# Modification 1 of Powerhouse Ultimo Revitalisation

State Significant Development Assessment Report (SSD-67588459 MOD 1)

**Figure 3 |** Wran Building / Galleria additional steel structure demolition works and glazing (Base source: Applicant’s modification)

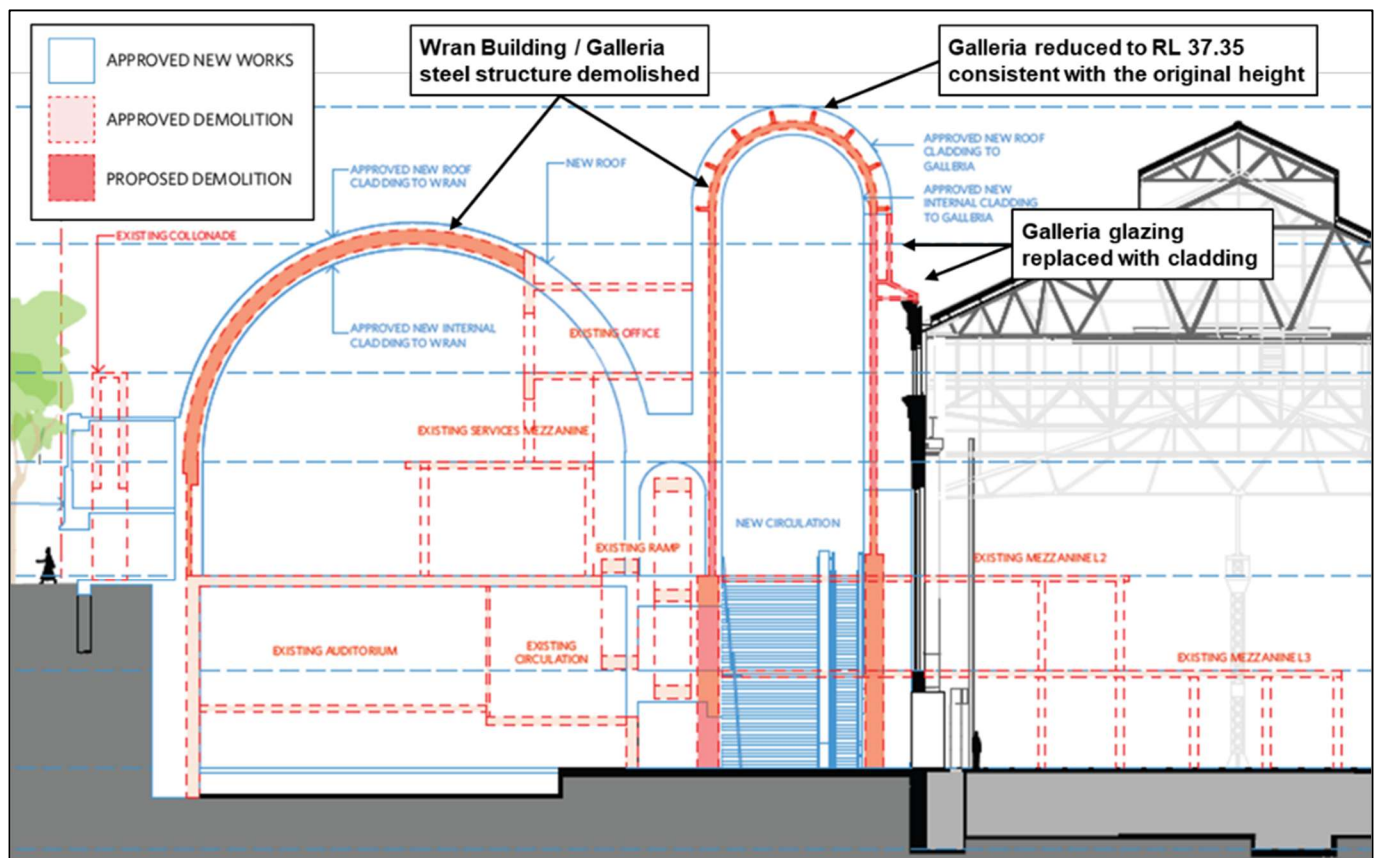
The modification seeks to amend the proposal to allow for the complete demolition and subsequent reconstruction of the Wran Building / Galleria and to delete conditions B13 and B14 relating to the retention of the Wran Building Structure. Additionally, it involves a minor reduction of the height of the Galleria's arch (by 0.215 m<sup>2</sup>) to match its original arch height and continuing the arc of the western arch to the Galleria compared to the existing structure.

Public submissions raised concerns about the loss of the Wran Building heritage fabric, and HNSW recommended retaining the existing steel structure. While Council objected to the demolition of the steel structure, it confirmed that the modification adequately explains why the structure cannot be retained in the current design.

To support the proposed modification, the Applicant submitted an Engineer's Structural Statement (ESS) and a Heritage Impact Assessment (HIA). The ESS concluded that the steel structure was compromised and recommended demolition due to safety concerns, inability to meet modern standards, and the impact of intrusive modifications, if retained. The HIA concludes that demolition

The Department has carefully considered comments from Heritage NSW, Council’s objections, and the Applicant’s responses. It concludes that demolition of the steel structure is unavoidable due to:

- structural limitations and uncertainties
- inability to meet modern loading and construction standards
- complex safety and construction challenges
- the need for intrusive modifications, such as cross-bracing, if retained.

The Department is also satisfied that the proposed changes would not result in any significant heritage impacts beyond those already assessed and approved. This is because:

- the reconstruction will allow the Wran Building’s distinctive double-arch form, appearance, and spatial qualities to be retained, with new fabric matching the original
- alternatively retaining the existing steel structure would require extensive interventions that would compromise spatial qualities and cause adverse visual and heritage impacts
- the minor reduction in the Galleria’s height aligns with the original building’s proportions.

- a like-for-like replacement of the steel structure in the Galleria to preserve the building's spatial qualities
- updating the Heritage Interpretation Plan (Condition B30) to include the Wran Building
- updating the Photographic Archival Recording (Condition B31) to specifically document the existing steel structure

**Figure 4** | Wran Building / Galleria steel structure and roof glazing (top) and proposed solid cladding and horizontal windows (bottom) (Base source: Applicant's RtS and additional information)

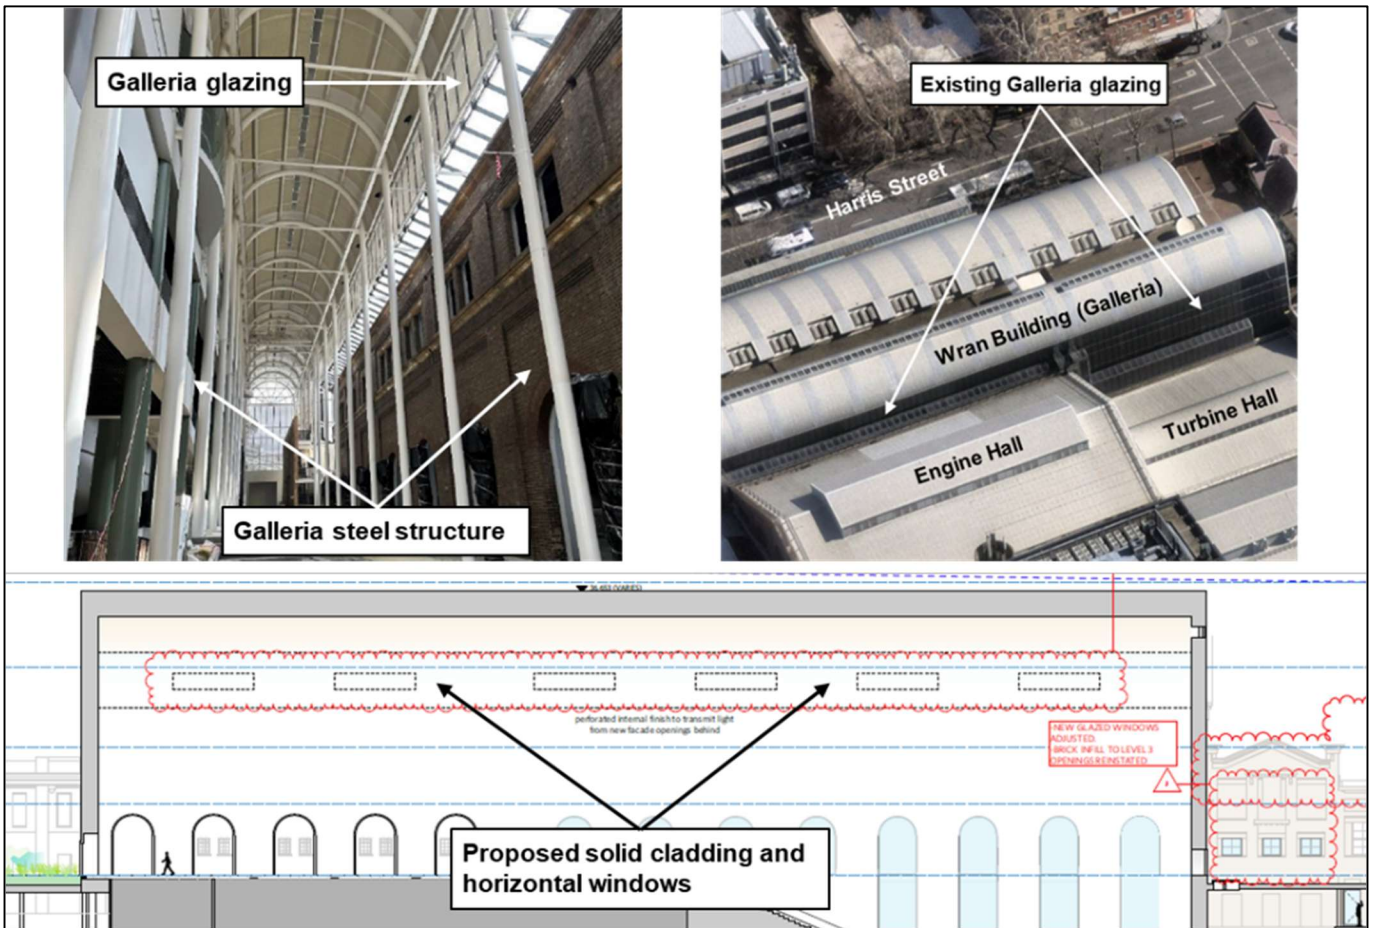
Issue	Findings and conclusions	Recommendation
<b>Galleria glazing</b>	The original approval includes the retention of vertical and sloped glazing located along the eastern roof of the Wran Building / Galleria.  The modification seeks to replace the glazing with solid cladding	The Department has recommended condition A2 include updated

Issue	Findings and conclusions	Recommendation
	<p>including horizontal windows (<b>Figure 4</b>).</p> <p>HNSW and Council does not support the replacement of the glazing with solid cladding, noting the glazing forms a key part of the original design of the Wran Building and provides built form separation between the Galleria and the Core Buildings.</p> <p>In response, the Applicant stated that replacing the glazing with solid cladding is necessary to address water ingress issues that have damaged the heritage fabric and require significant ongoing maintenance, and that retaining the glazing would also result in adverse heat gain within the proposed Galleria space.</p> <p>The Department has carefully considered HNSW’s comments and the Applicant’s response. The Department considers that the replacement of glazing with solid cladding is on balance, acceptable as:</p> <ul style="list-style-type: none"> <li>• the existing glazing is not readily visible from any public area or vantage point</li> <li>• the original approval includes the construction of an internal skin within the Galleria, which would largely obscure the internal view of the glazing (and the built form separation of buildings) from within the Galleria space</li> <li>• the proposal includes horizontal windows, which would provide natural light to the Galleria space.</li> </ul>	<p>plan references.</p>
